SUBJECT: WATERFORD STEAM ELECTRIC STATION, UNIT 3 - ISSUANCE OF  
AMENDMENT NO. 267 RE: REACTOR COOLANT SYSTEM  
PRESSURE/TEMPERATURE LIMITS AND LOW TEMPERATURE  
OVERPRESSURE SETPOINTS APPLICABLE FOR 55 EFFECTIVE FULL  
POWER YEARS (EPID L-2021-LLA-0165)

Amendment No. 267  
Renewed License No. NPF-38

SAFETY EVALUATION BY THE OFFICE OF NUCLEAR REACTOR REGULATION

FIGURE 3.4-2

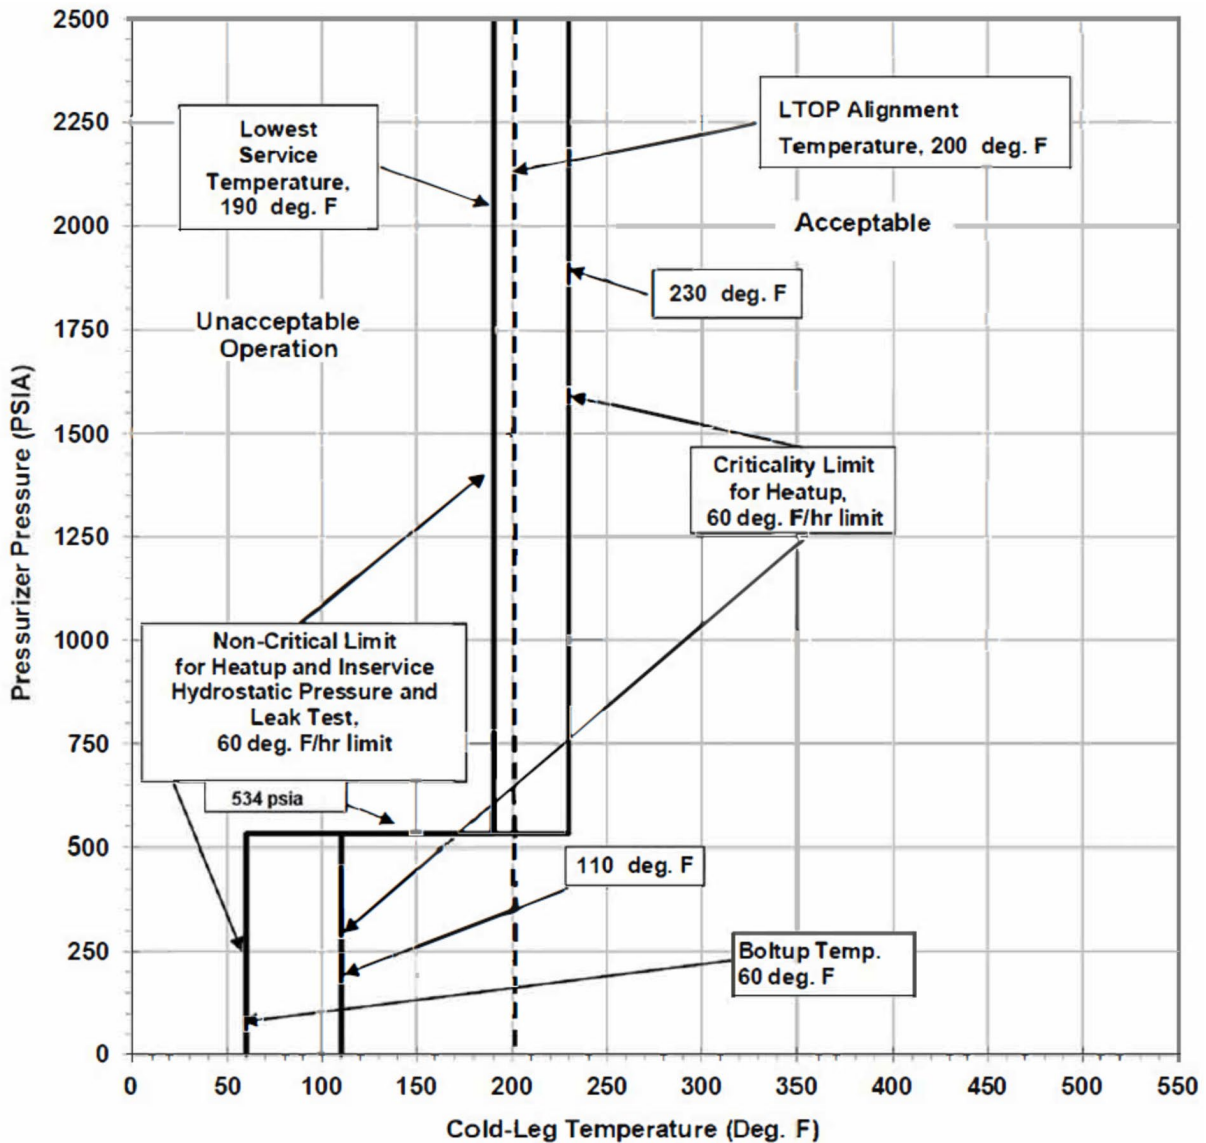
The amendment updates Waterford 3 figures in TS 3.4.8.1, which contain the reactor coolant system, pressure/temperature (P/T) limit curves for 32 effective full power years (EFPY), with curves that are applicable up to 55 EFPY. This amendment also revises the low temperature overpressure protection P/T region pressurizer pressure limit from 554.1 pounds per square inch absolute (psia) to 534 psia to account for three reactor coolant pump operation.

identical to those for 32 EFPY, the difference being that the LTOP P/T region pressurizer pressure limit was lowered to 534 psia (from 554.1 psia) to account for three RCP operation. The licensee described the lowering of the pressurizer pressure limit in section 2.2.3 of the enclosure to the LAR application. The licensee stated that the P/T limits currently specified by TS section 3.4.8.1 figures 3.4-2 and 3.4-3 for 32 EFPY were generated in accordance with 10 CFR Part 50, Appendix G and have been approved by the NRC.

- (2) The NRC staff finds the revision of pressurizer pressure limit from 554.1 psia to 534 psia applied to the TS section 3.4.8.1, figures 3.4-2 and 3.4-3, to be acceptable, as discussed in section 3.1.4.3 of this SE.

Per the licensee, Westinghouse developed a pressure correction factor (PCF) that is appropriate for three RCP operation within the LTOP region (91 per square inch differential, excluding instrument uncertainty). Based on the new PCF value used by the licensee, the actual pressurizer pressure limit is revised from 554.1 psia to 534 psia and applied to TS section 3.4.8.1, figures 3.4-2, "Waterford Unit 3 Heatup Curve" and 3.4-3, "Waterford Unit 3 Cooldown Curve".

Since the LTOP transient peak pressure (491 psia) was within the proposed updated pressurizer pressure limit for the Waterford 3 heatup and cooldown curves, the NRC staff finds the revision of the pressurizer pressure limit from 554.1 psia to 534 psia applied to the TS section 3.4.8.1, figures 3.4-2 and 3.4-3, to be acceptable and that it meets the criteria of GDCs 15 and 31 contained in Appendix A to 10 CFR 50.
